**Oakdale South Industrial Estate - s96(2) Modification Application (SSD 6917 MOD 1)  
Submission on behalf of Jacfin Pty Ltd**

**Re: Proposed modification to Oakdale South Estate  
Noise Assessment**

*Oakdale South Estate S.96 Modification Operational Noise Impact Assessment Report Number  
630.11166-R3 22 September 2016 (**Noise Report**)*

Figure 19: Area of Noise Exceedance During Adverse Weather Conditions

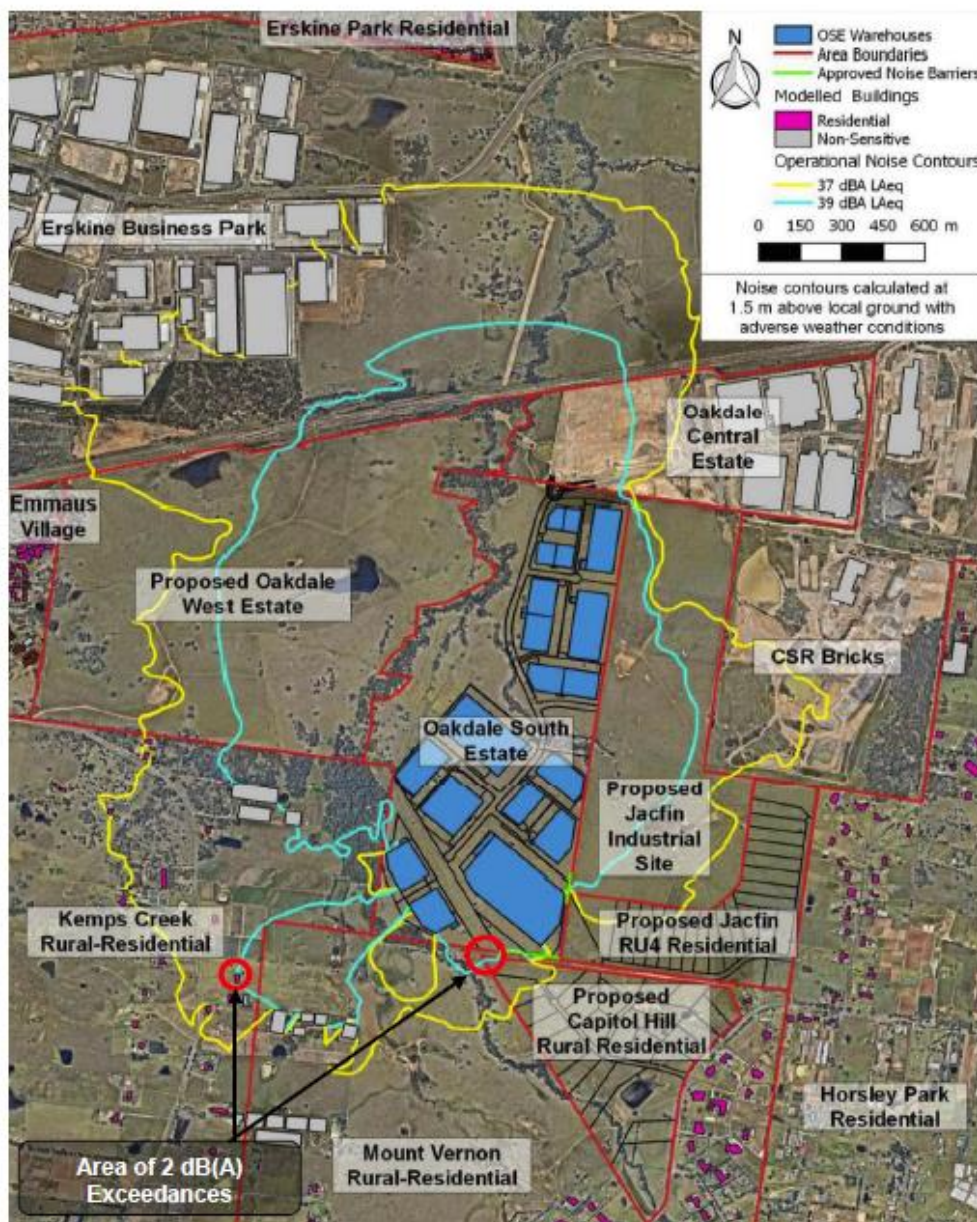
A review of the Department of Planning's State Significant Assessment Report for Oakdale South Industrial Estate reveals that the 40 dBA criterion was applied to the L3 receiver area. The reasoning being that SLR noise modelling under adverse weather conditions indicated that a 2 dBA exceedance of the PSNL would occur at Kems Creek and Capitol Hill rural residential areas. The assessment concluded:

*Based on the results of the Applicant's noise assessments, the Department has concluded the development contemplated under the Concept Proposal will comply with the PSNLs during normal weather conditions at all receivers. However, where Class F temperature inversions occur, a minor exceedance of 2 dB(A) is predicted at two properties outside of the site. One is adjacent to the southern boundary and the other at the nearest residential dwelling 500 m to the south west (see Figure 19).*

However, with the revised reorientation of buildings as proposed by the S96 application, the grouping of Kems Creek, Mt Vernon, Jacfin and Capitol Hill into one receiver group with an allowable noise limit up to 40 dBA potentially exposes future residences located in the Jacfin Residential Land to higher noise levels than were presented in the original Oakdale South application to the Department.

Applying this reasoning, a fourth receiver area (say L4) representing the Jacfin Residential Land and Mt Vernon Land should be added and the PSNL of 38 dBA should be applied to this area. The approved criteria of 40 dBA for the L3 area, consisting of the Kemps Creek and Capitol Hill areas, could be retained for these receiver areas.
